Mega Washing & Dyeing Ltd

06th March, 2017

Observations

1st Floor layout plan.

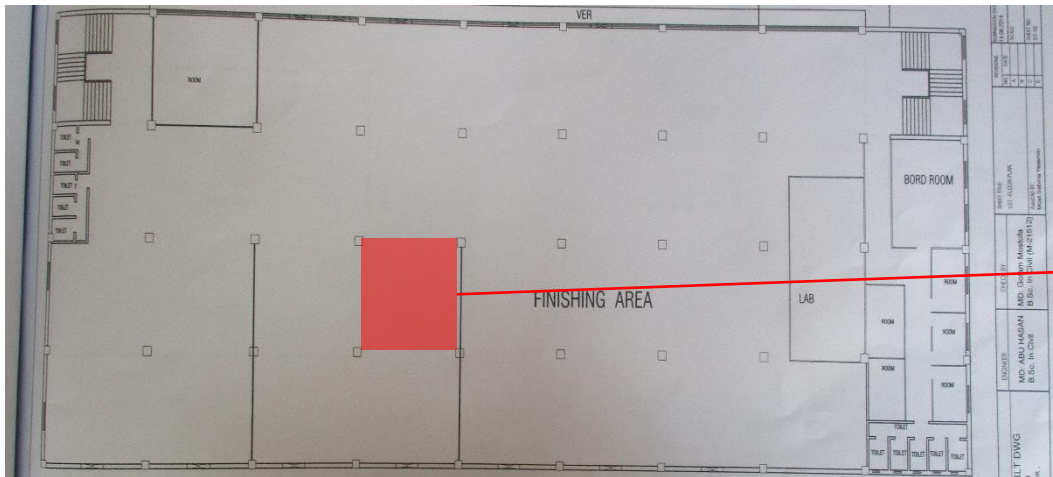
Hairline cracking was observed on the soffit of 1st floor slab in several location. Building Engineer to investigate extend of crack and suggest remedial actions as required.

Column Layout

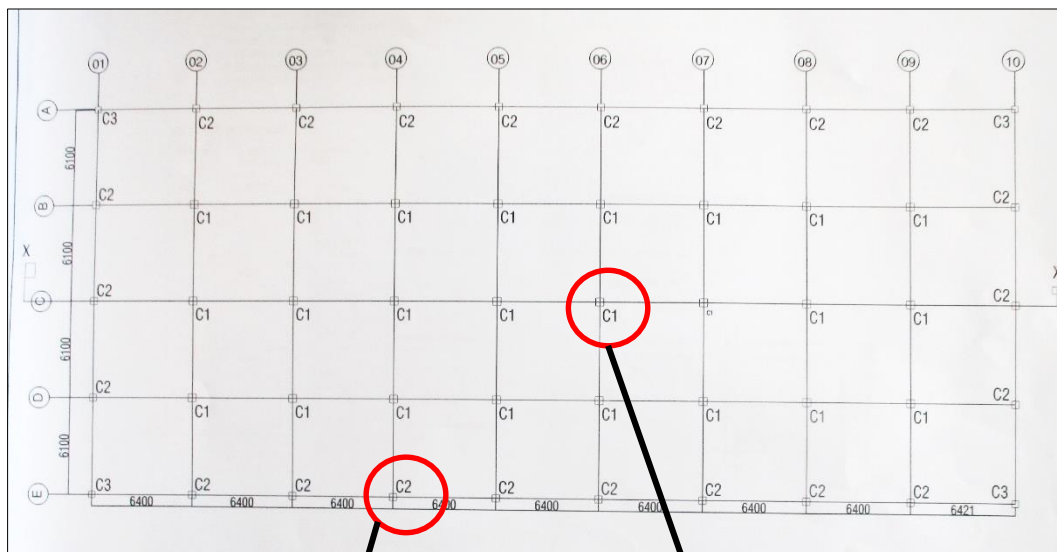
Discrepancy between as built drawing and site observation

Column schedule in as built drawing

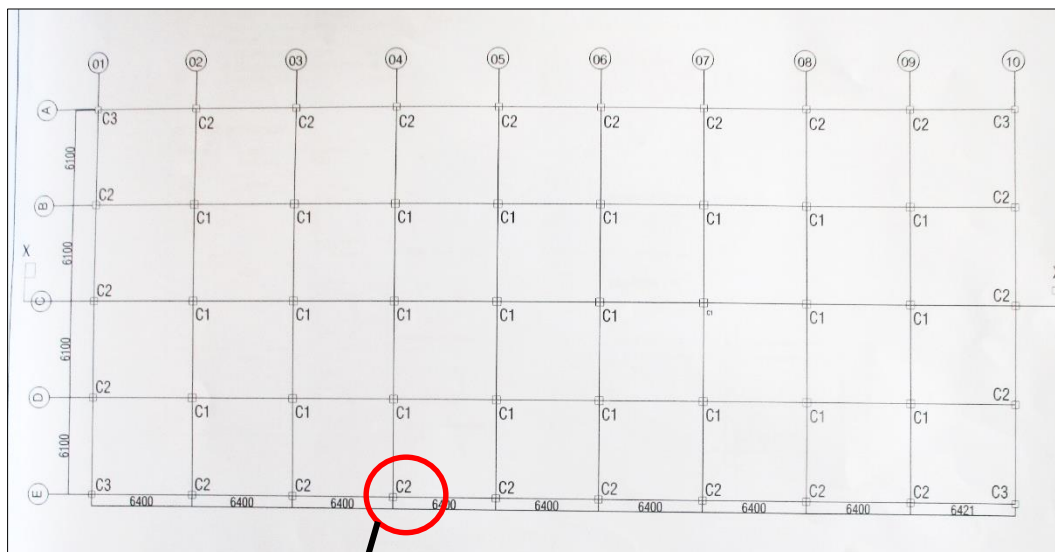
Dimensions of all columns were found 480mmX480mm with render on 1st floor where column schedule indicates that the dimensions of C1 type column should be 500mm x 500mm and C2 type should be 450mmx 450mm

Column schedule in as built drawing

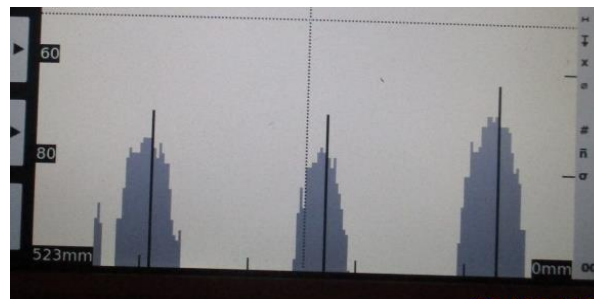
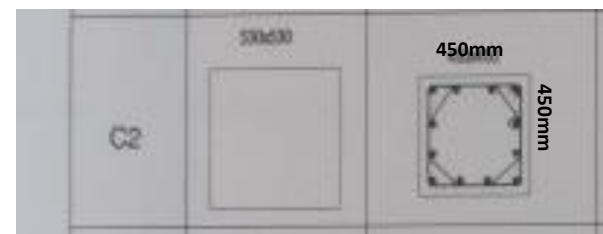
3 nos. bar was found on each side with ferro scanning.

From the column schedule of as-built structural drawing C2 type column has 4no's rebar at each side. But from ferro scanning Image it was confirmed that there is 3 no's of rebar in each side of this type of column.

Untied and loose vertical bracing at east side.

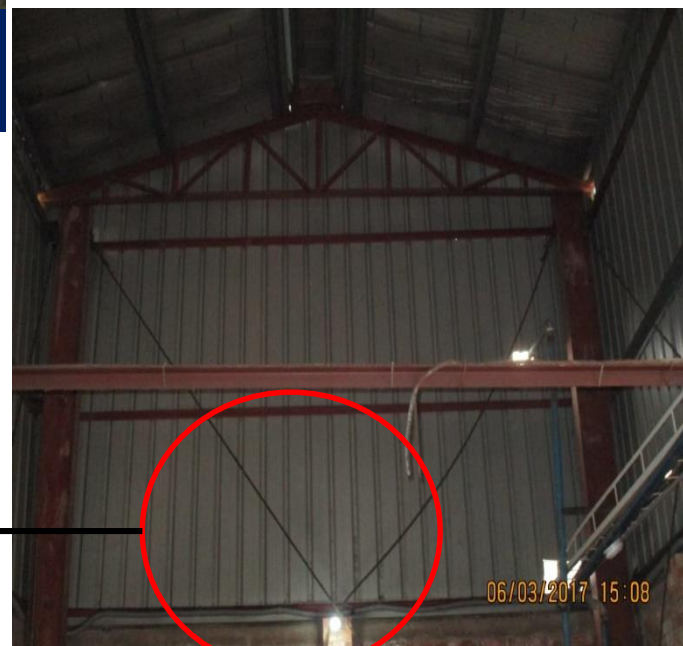
Vertical bracings were found untied and loosely connected with columns. Bracings were missing at west side of the structure. Corrosion were observed at support of the columns. Factory engineer to review the design for lateral stability and suggest proper remedial action regarding corrosion and stability.

A two storied RC part of utility shed.

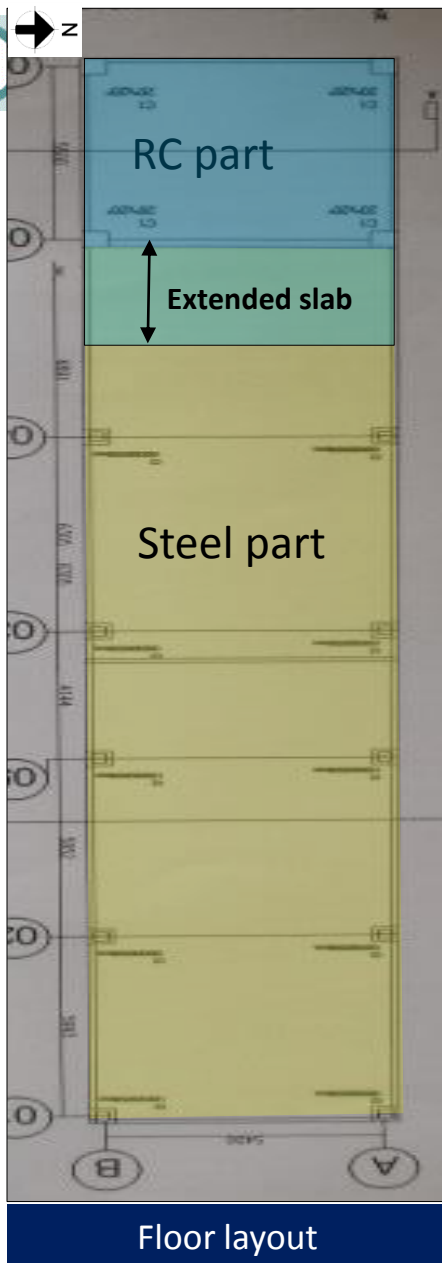
Two storied RC part including 4.7m extension of slab was not included in drawings. Additionally bracings and connection details for steel part of utility shed were not available.

Factory engineer need to produce a set of as-built drawings considering actual condition.
